Docket Number:	23-AFC-03
Project Title:	Black Rock Geothermal Project (BRGP)
TN #:	250369
Document Title:	Black Rock Geothermal Project Data Adequacy Response Set 1
Description:	N/A
Filer:	Jerry Salamy
Organization:	Jacobs
Submitter Role:	Applicant Consultant
Submission Date:	5/29/2023 8:46:30 AM
Docketed Date:	5/29/2023

Data Adequacy Supplement

Black Rock Geothermal Project
(23-AFC-03)
May 26, 2023

Figure DA3.0-1
Visual Representation of Transmission Line Section,
Black Rock Geothermal Project
Imperial County, California

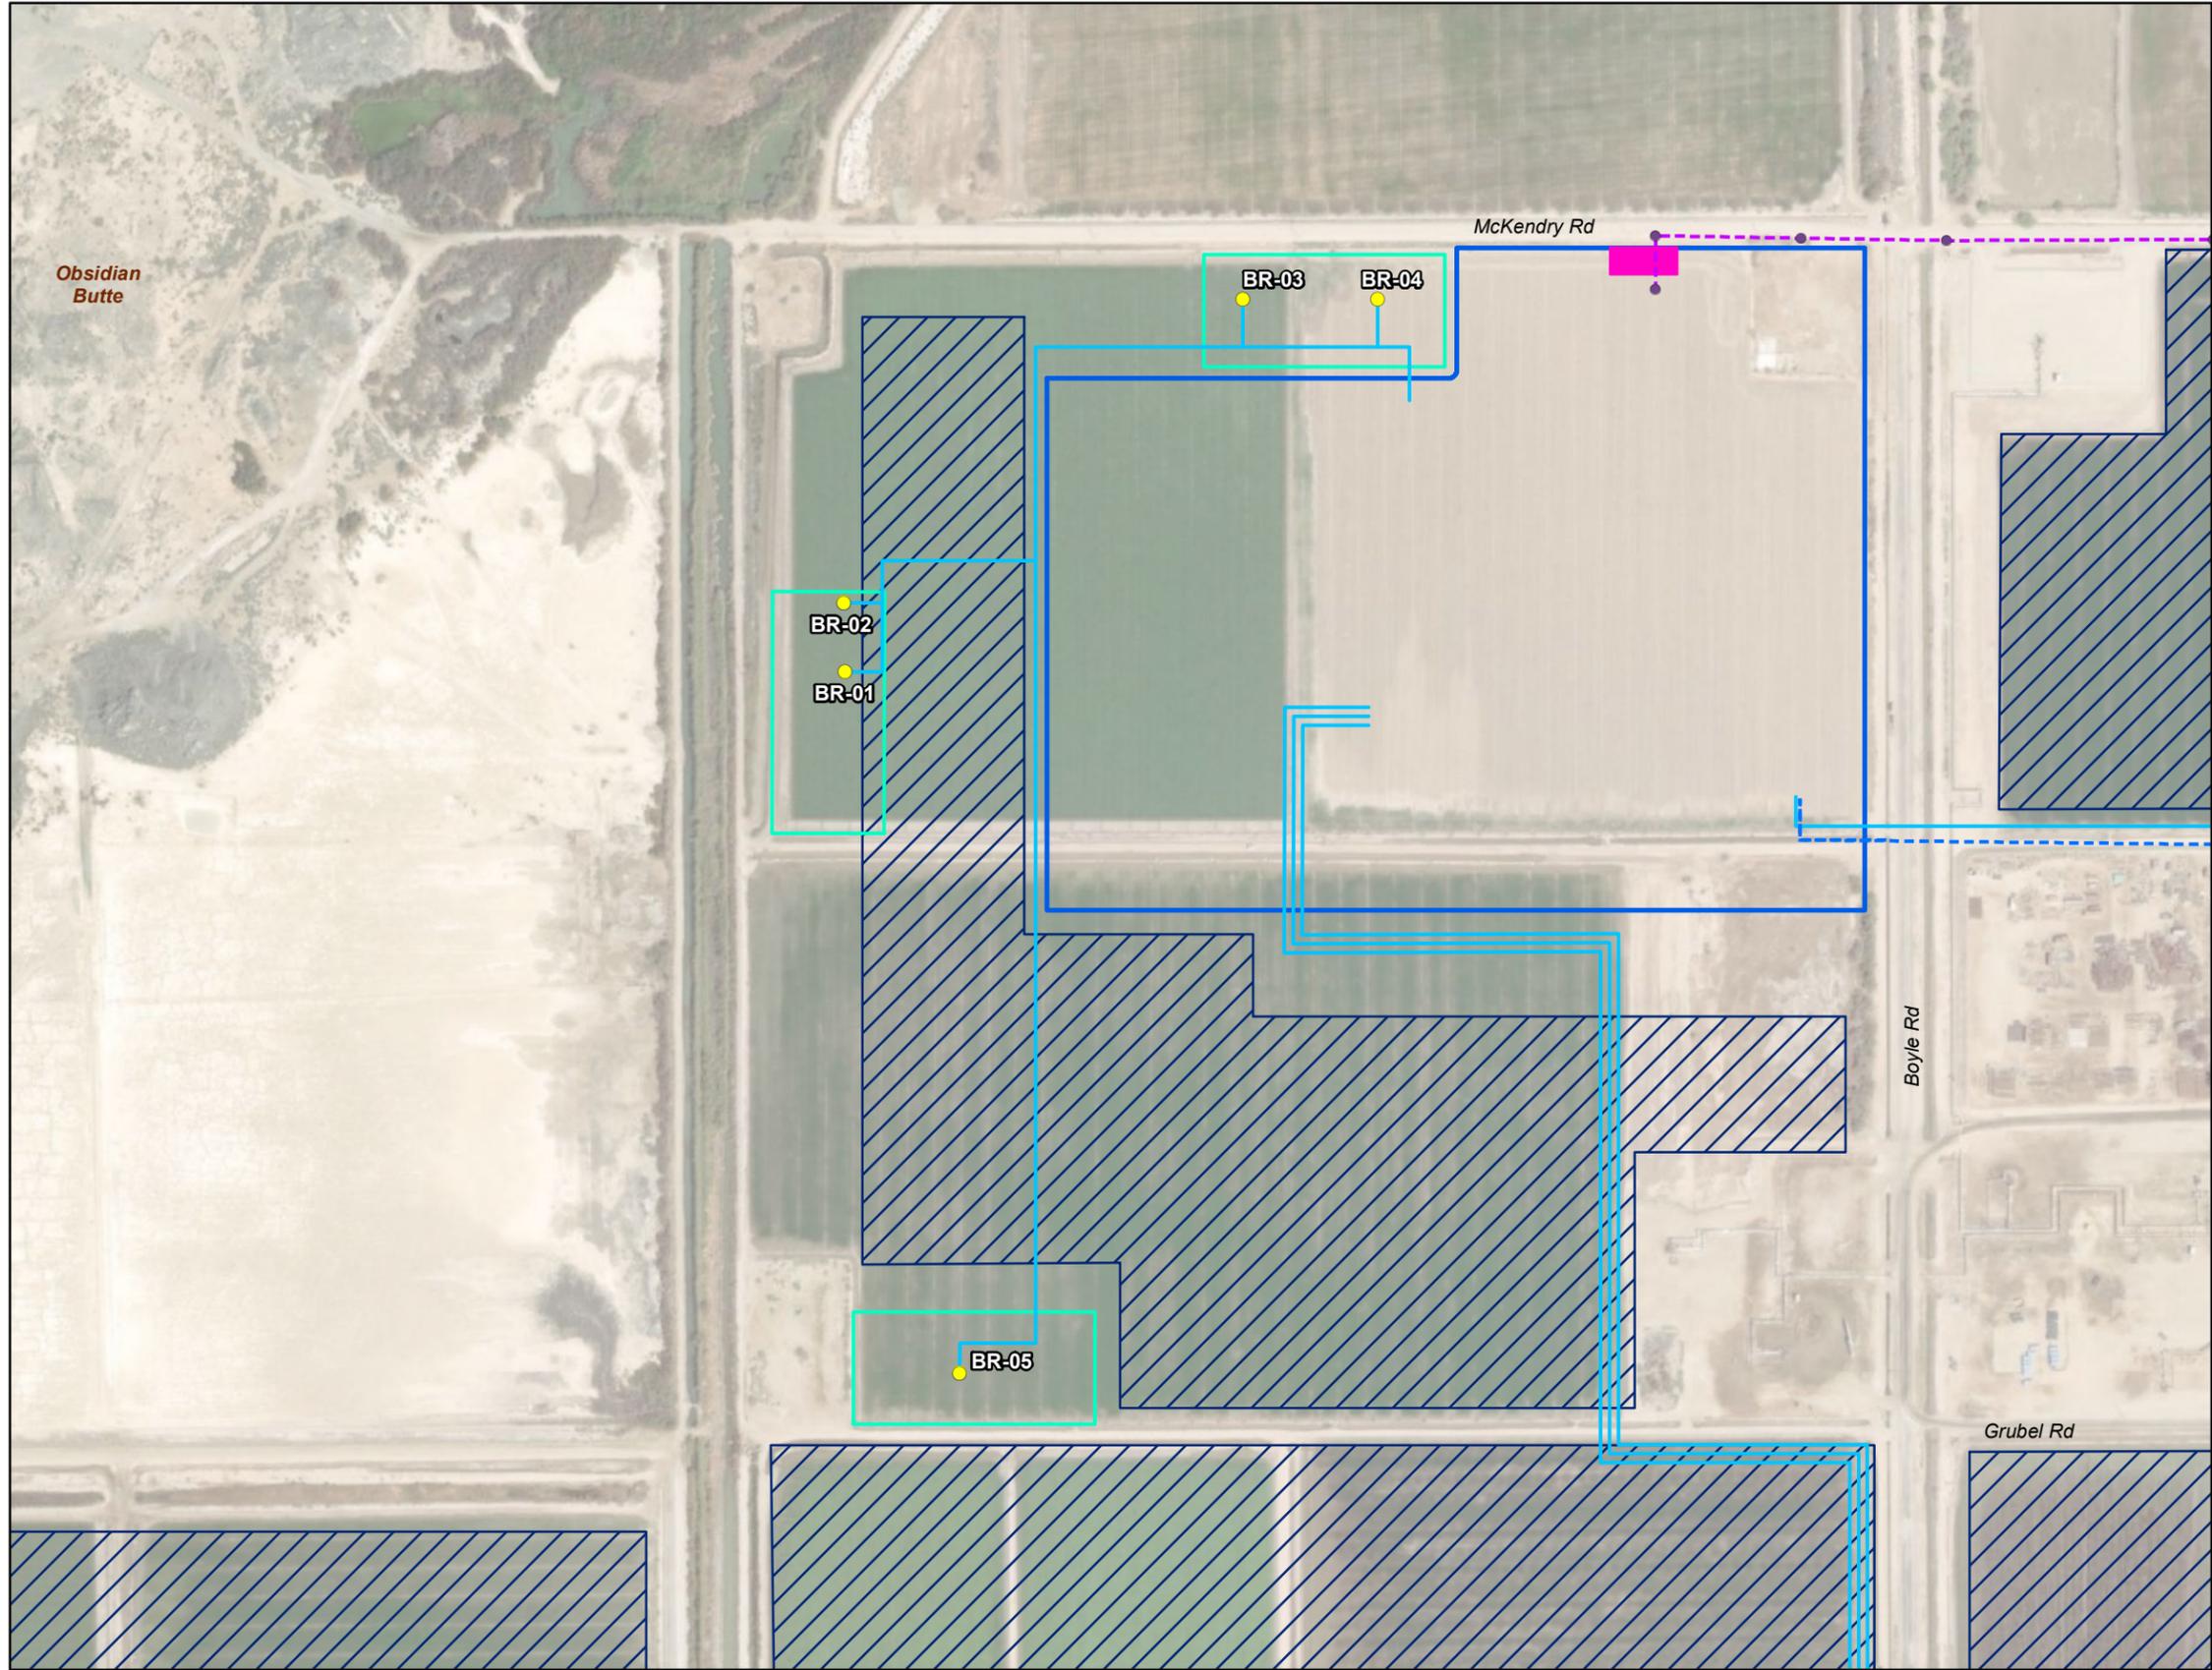
A full-page color photographic reproduction depicting a representative above ground section of the transmission line route prior to construction and a full-page color photographic simulation of that section of the transmission line route after construction.

There are one-line drawings on an aerial photo showing the alignment of all T-line alignments, Figure 5.13-2f includes a visual simulation of the T-line, and Appendix 3 contains a rendering of individual towers, but not a section. A visual representation of a section is requested.

Response: Figure DA3.0-1 presents a visual representation of a generation tie line section showing two transmission poles and conductors.

Figure DA4.0-1a
Production Wells
Black Rock Geothermal Project
 Imperial County, California

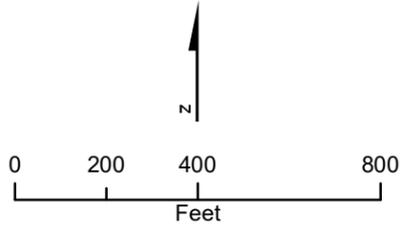
Detailed discussion with well numbers, of all wells and well pads, including production, injection, and make-up wells, along with diagrams at a suitable scale, should be included in the AFC, as part of the larger discussion of the geothermal leases and site selection, suggest 2.3.3 with discussion headings for each well type.

Response: Figure DA4.0-1a shows the three production well pads and wells BR-01 to BR-05, at a suitable scale. The well pad with well BR-05 has sufficient space for additional wells to be added.
